Z-15 (2017) PROPOSED R-20/OSC PLAN

PETITION NO: Z-15

ZONING COMMENTS:

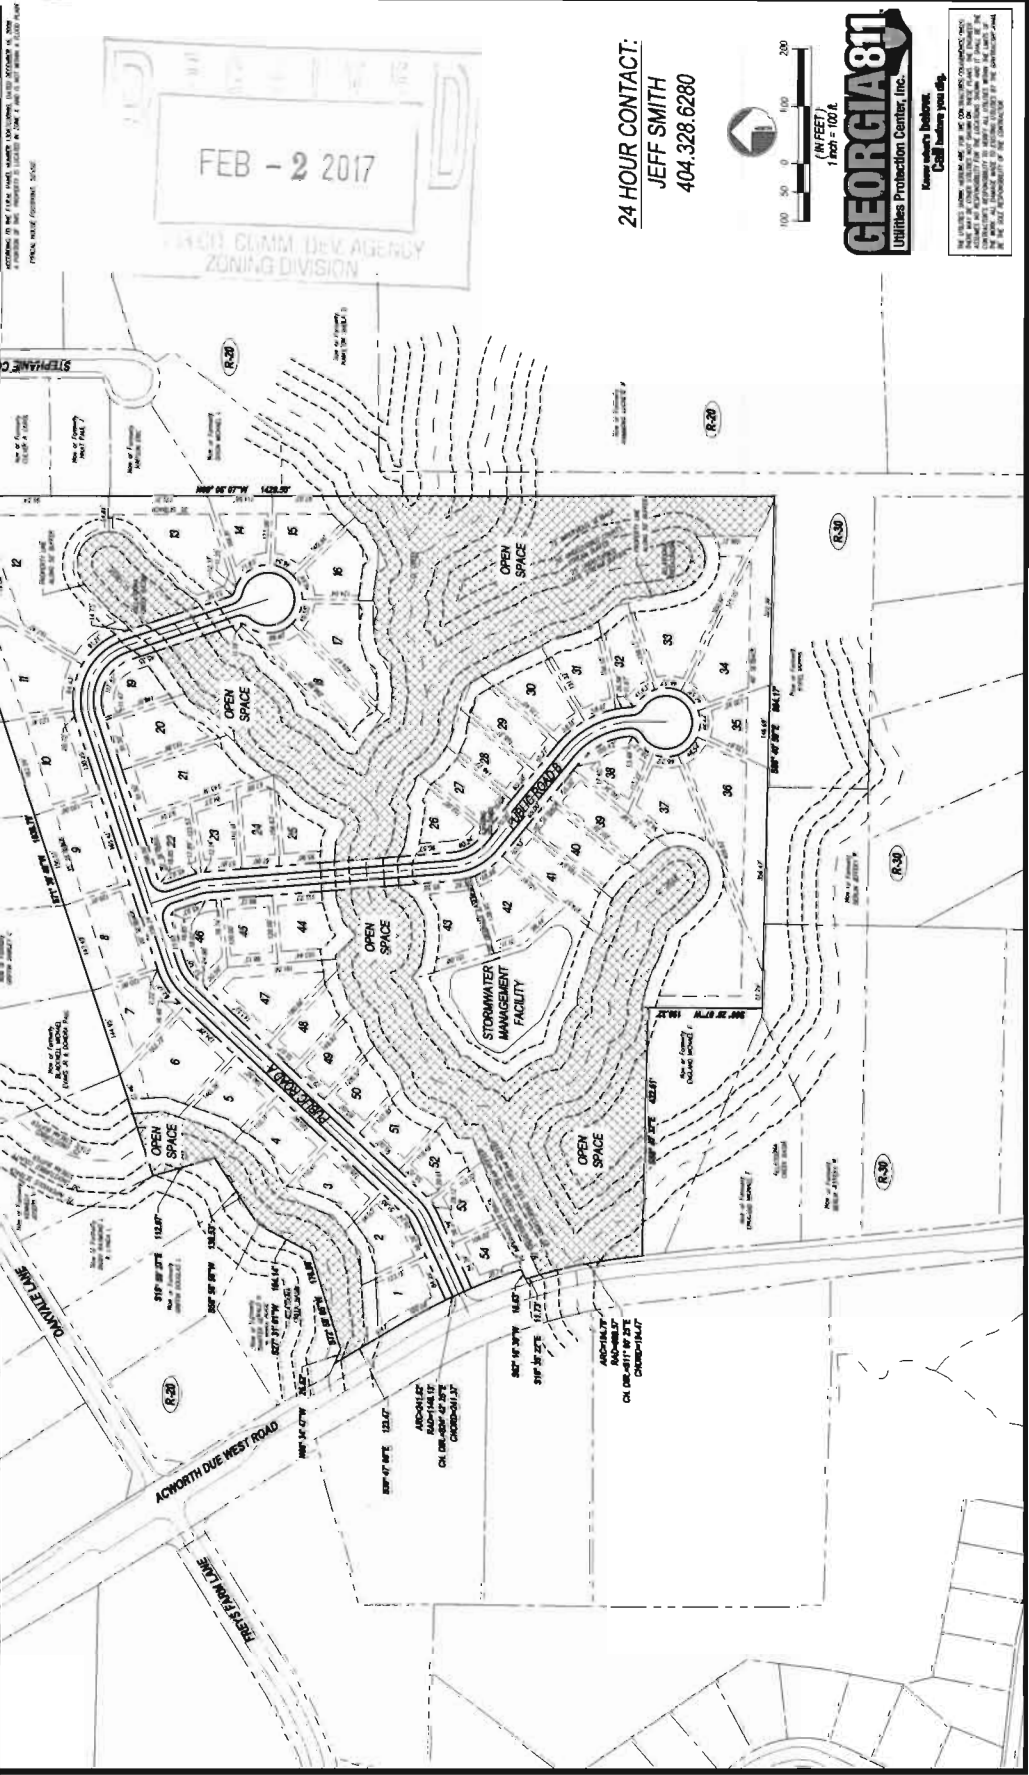
- 9. According to the straight, preliminary R-20 layout that was submitted with the OSC plan there are several lots that can't be built on due to stream buffers and the concern of an additional stormwater management facility. Comparison of plans would not yield a sufficient analysis.

- 10. If walking or bike trails are proposed throughout open space please add them to site plan and note that they must be constructed of porous materials.

2. The straight R-20 plan provided has 12 lots (2, 16, 17, 23, 24, 34, 37, 40-43, & 48) that appear to be too impacted by stream buffers to be viable.
3. The lot for the proposed stormwater management facility located behind Lots 42 & 43 must be extended to the public right-of-way (with minimum 20-foot width). It cannot be accessed by an easement through private property.

4. It is very likely that a second stormwater management facility will be required somewhere in the vicinity of Lots 1-4 to provide adequate detention and water quality for the development. This will probably mean the loss of one or two lots.
